NEW UG CHILLED WATER LINES – WEST SIDE USU
OSE# R0324-12X/DEL
SDSU# 25-15440
South Dakota State University
Brookings, South Dakota
2025

ADDENDUM NO. 1
March 17, 2025

VAULT AND STUDENT UNION ELECTRICAL PLAN

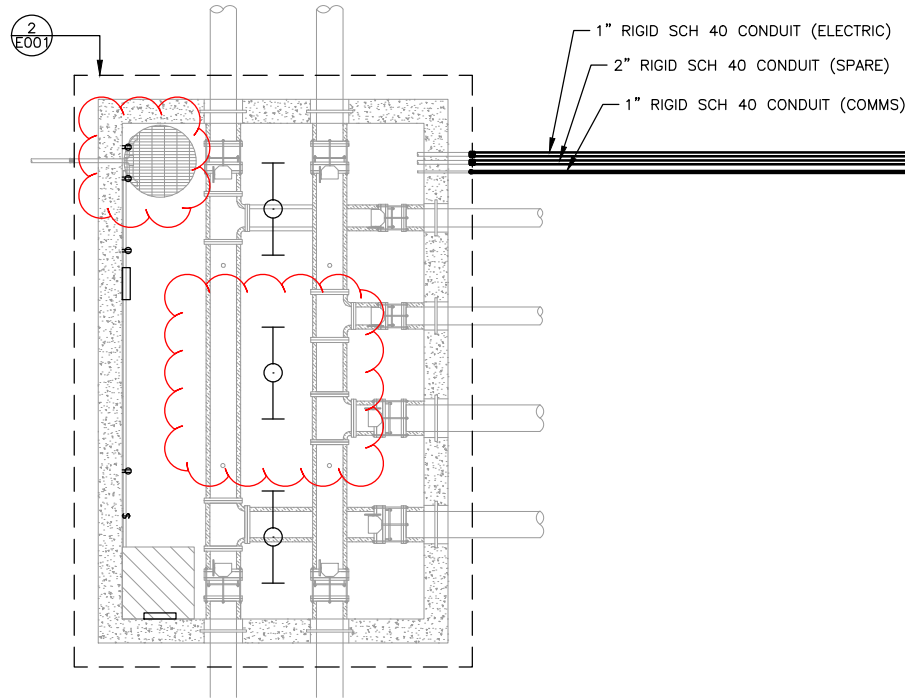
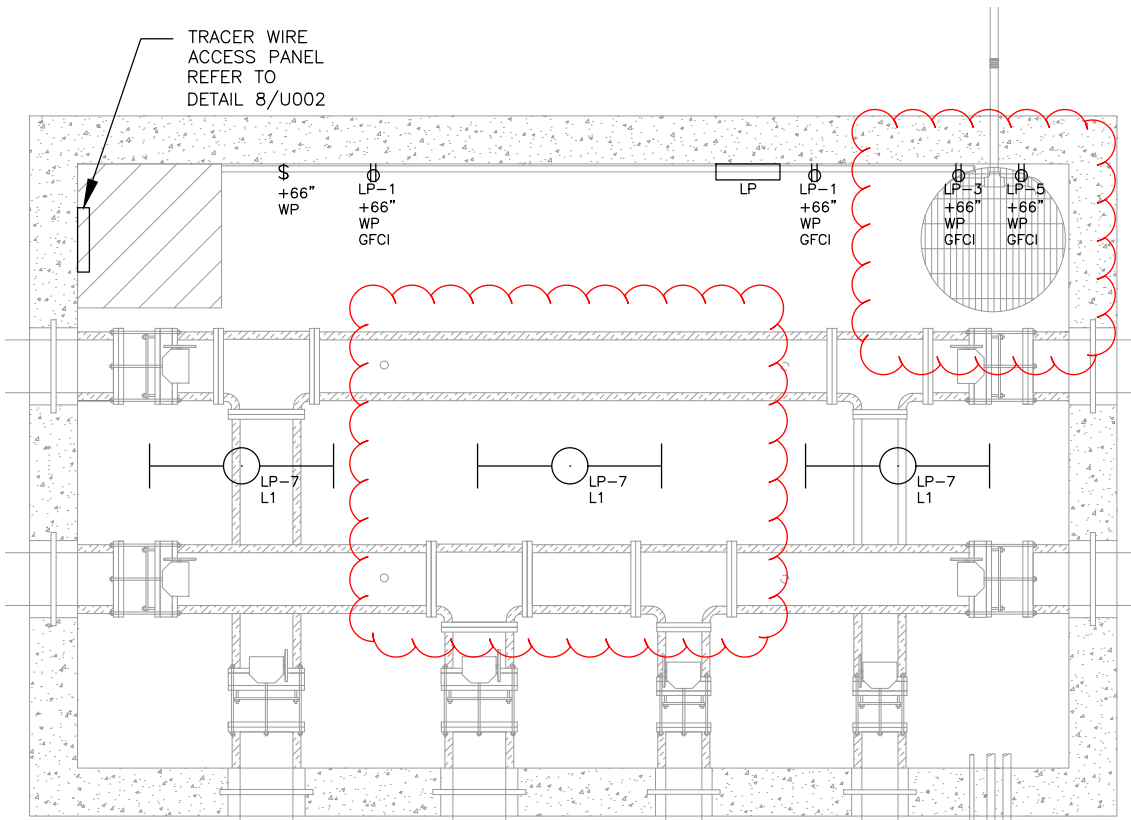
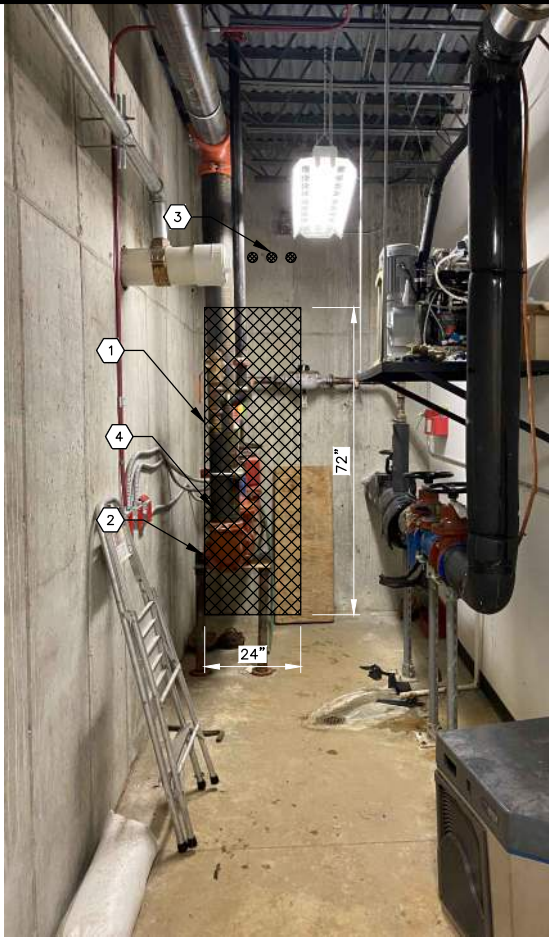
5. Sheet E001 – VAULT AND STUDENT UNION ELECTRICAL PLAN:

Replace sheet in its entirety with attached.

Removed rebar and foundation shown on S sheets.

I-UTILITY PLAN AND PROFILE
CHILLED LINES - INTERIOR BUILDING PLAN

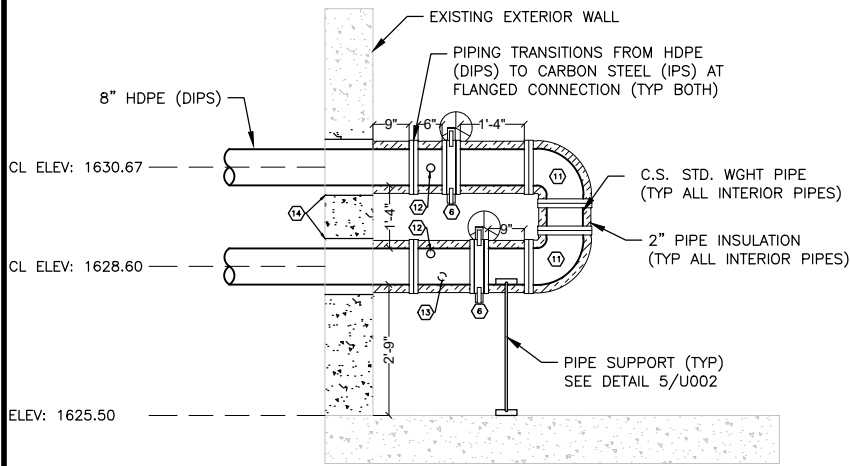
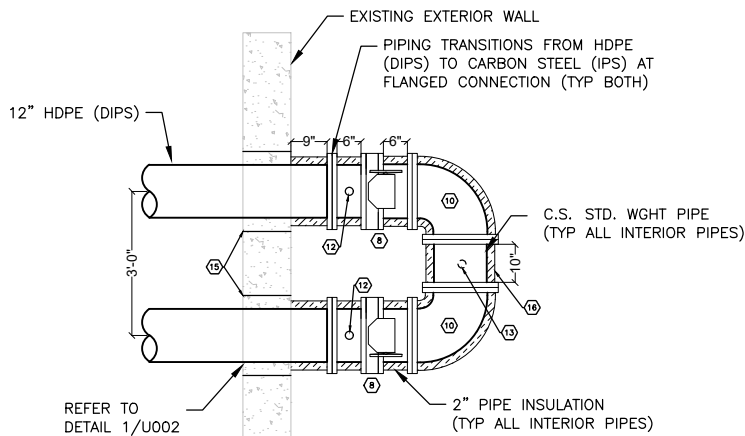
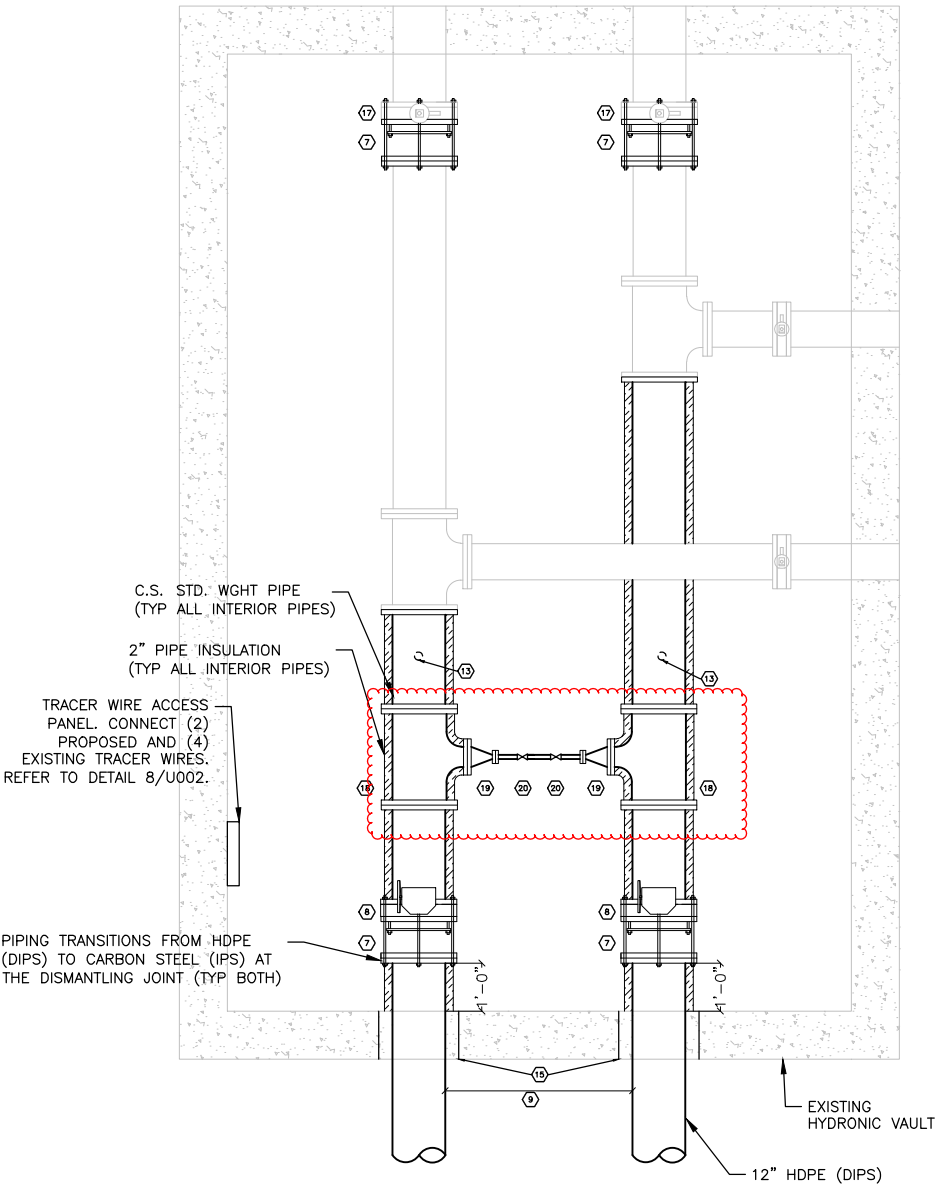
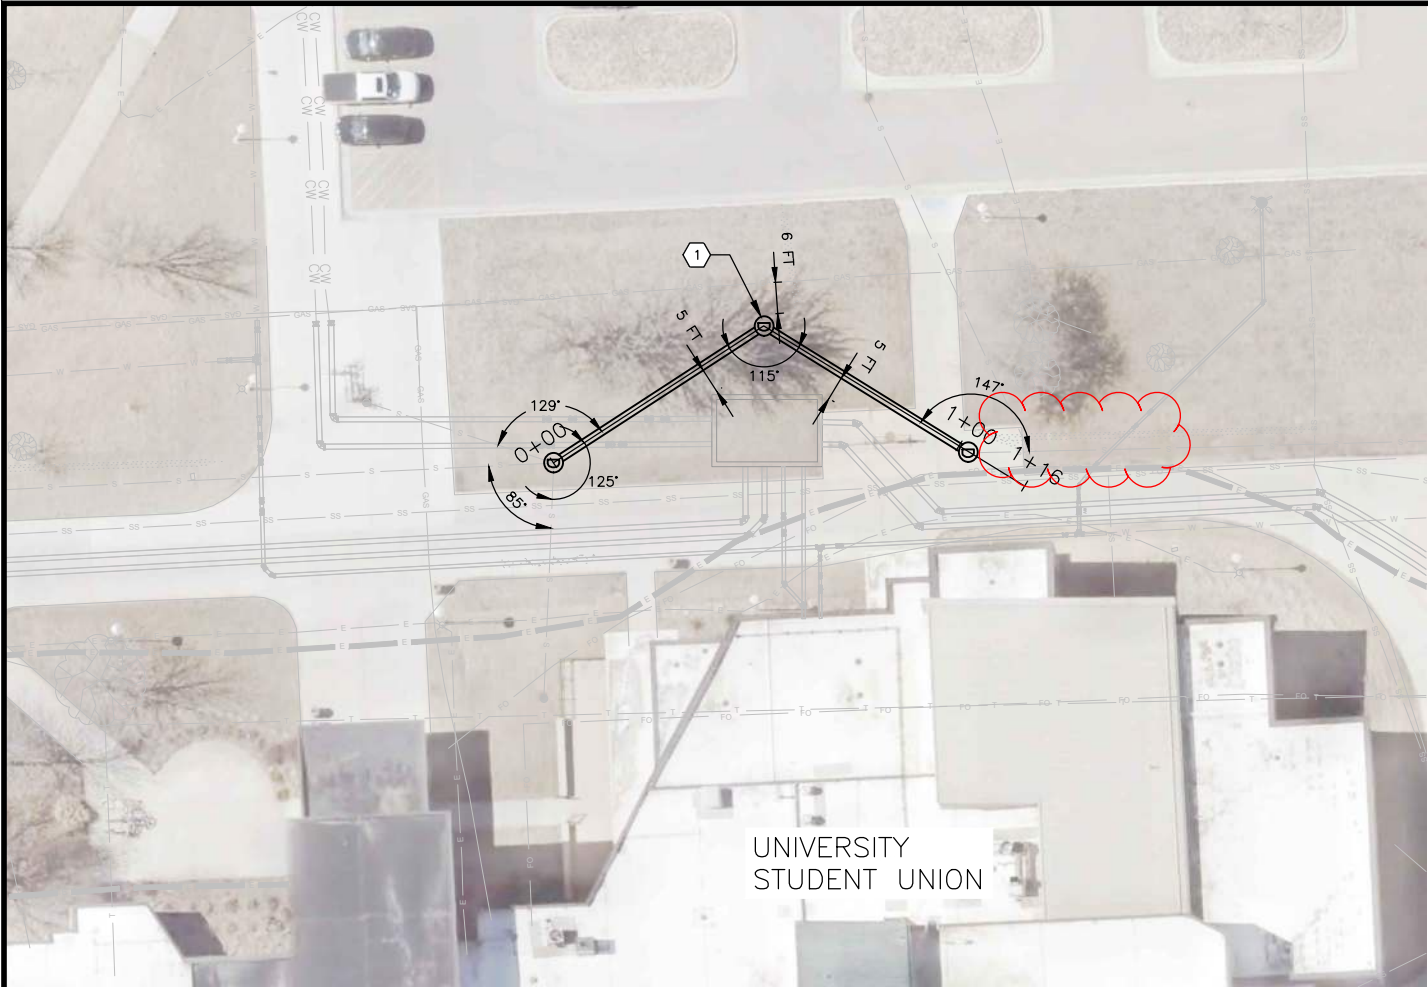
7. Sheet I007 – CHILLED LINES – INTERIOR BUILDING PLAN:

Replace sheet in its entirety with attached.

Added cleaning and recirculation piping.

STORM SEWER – PLAN AND PROFILE

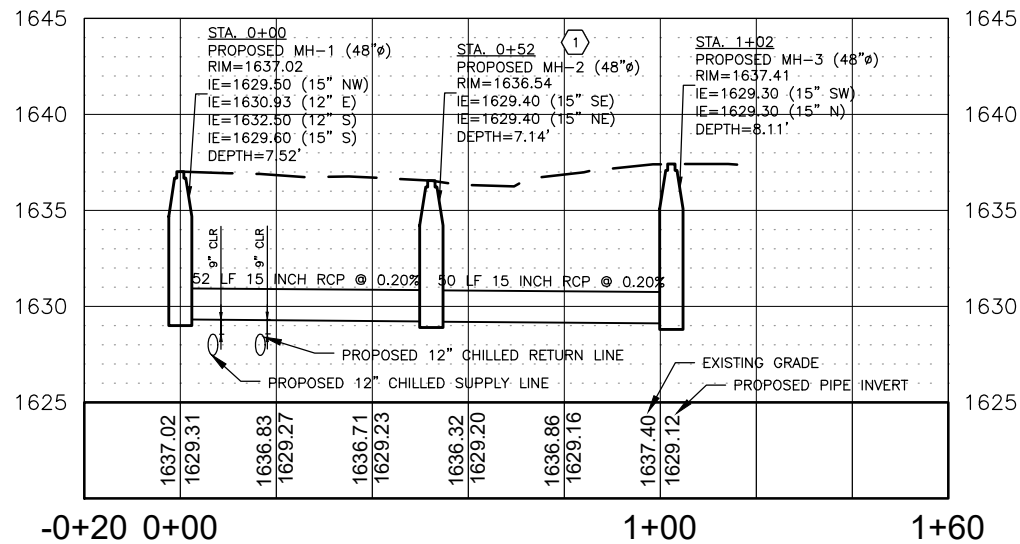
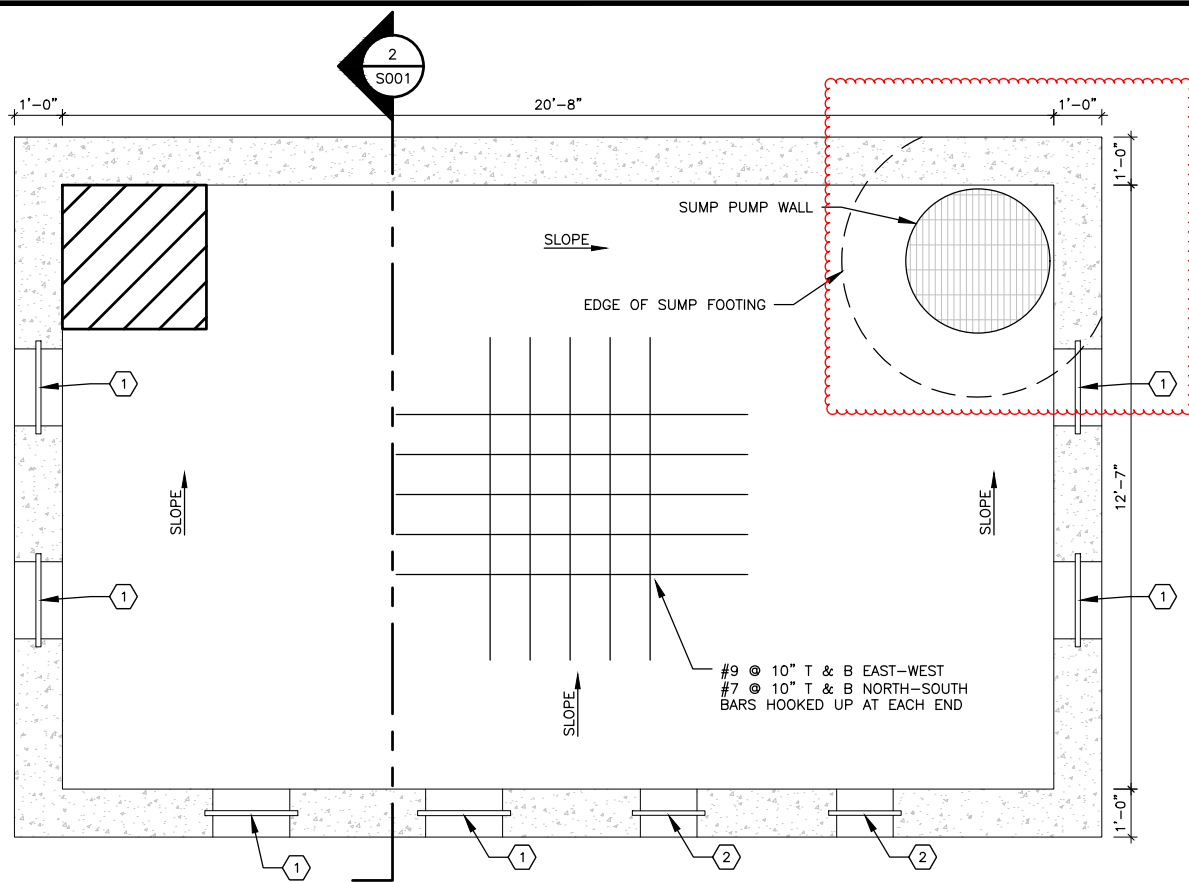
8. Sheet I201 – STORM SEWER – PLAN AND PROFILE:

Replace sheet in its entirety with attached.

Update to existing storm sewer manhole location.

HYDRONIC VAULT STRUCTURAL PLAN

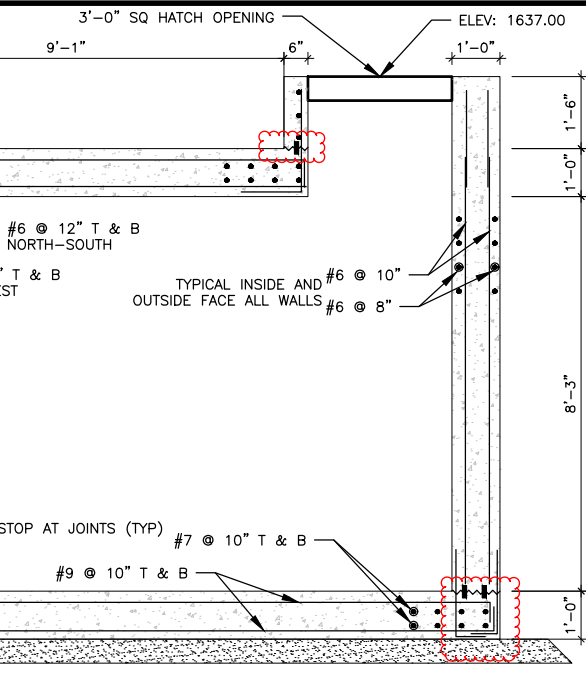
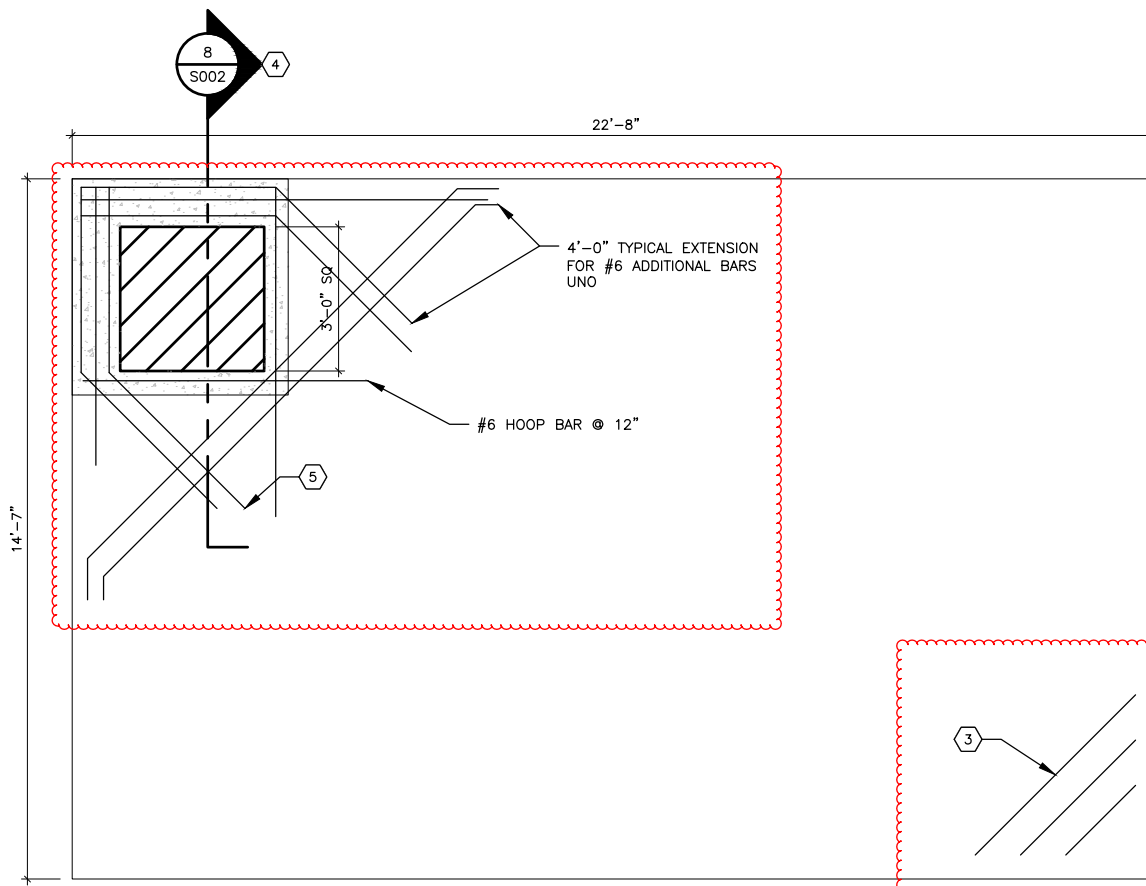
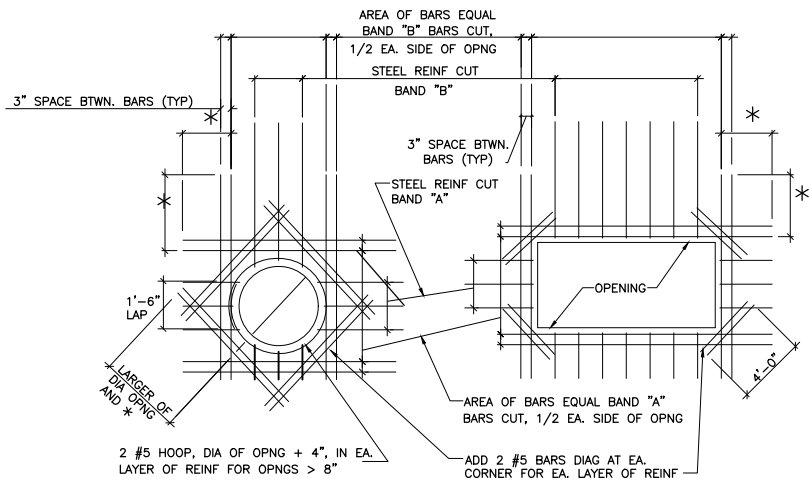
9. Sheet S001 – HYDRONIC VAULT STRUCTURAL PLAN:

Replace sheet in its entirety with attached.

Update rebar reinforcement, keynotes 1 & 2, and design criteria.

SHEET NO.
S002

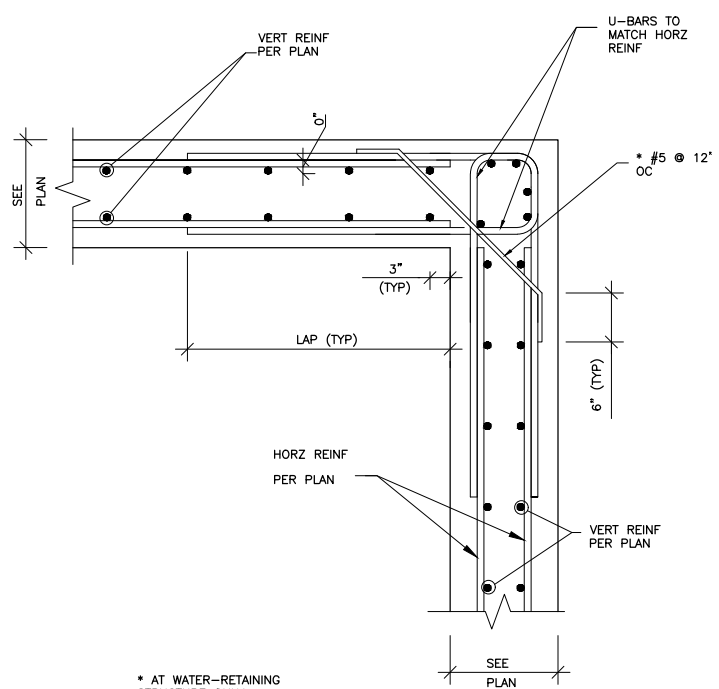
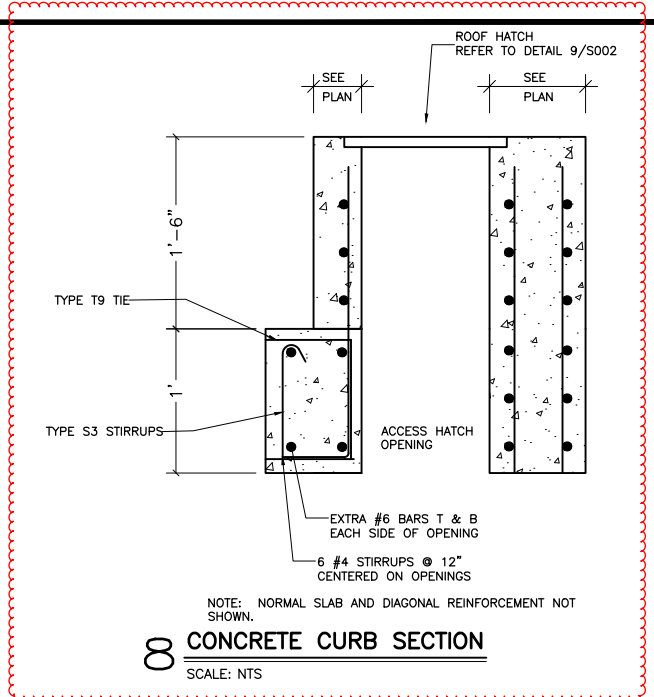
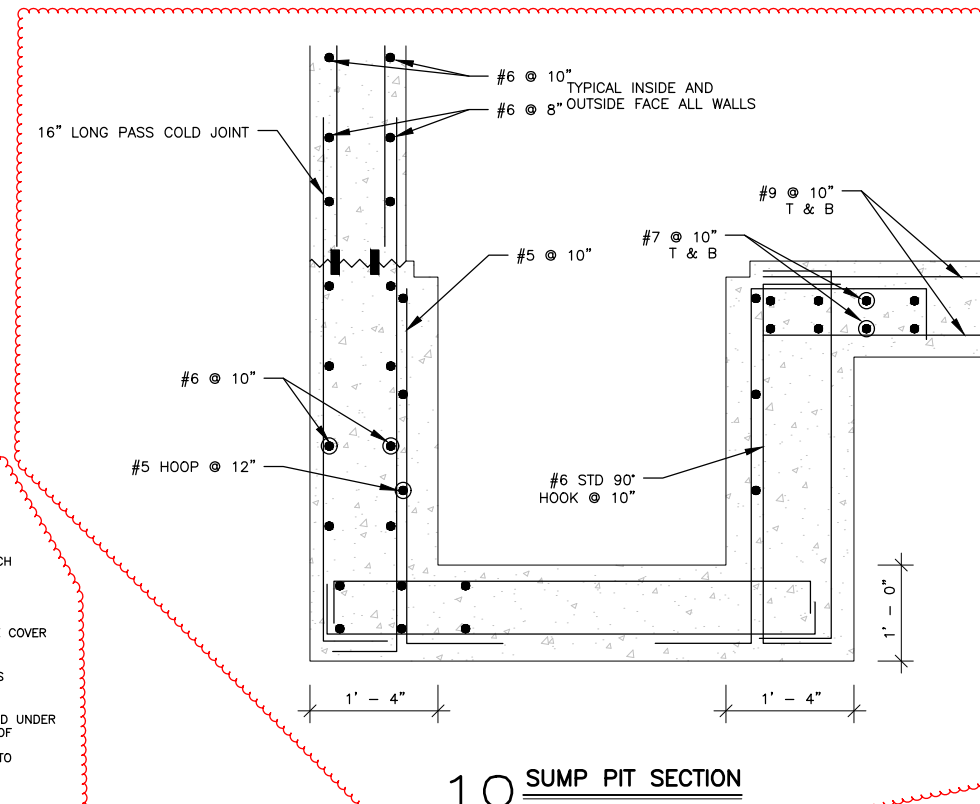
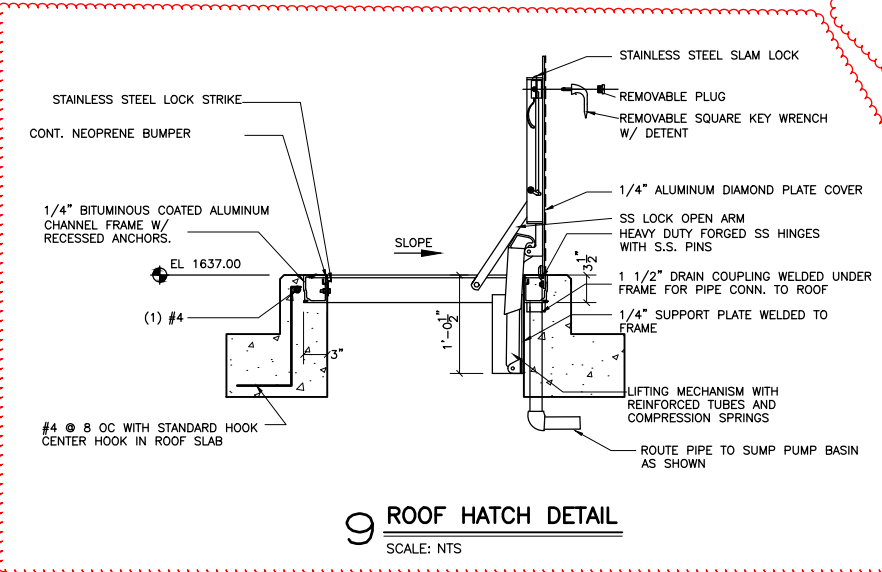
10. Sheet S002 – STRUCTURAL DETAILS:

Replace sheet in its entirety with attached.

Updated concrete strength, clarified Detail 8 and 9, and added Detail 10.
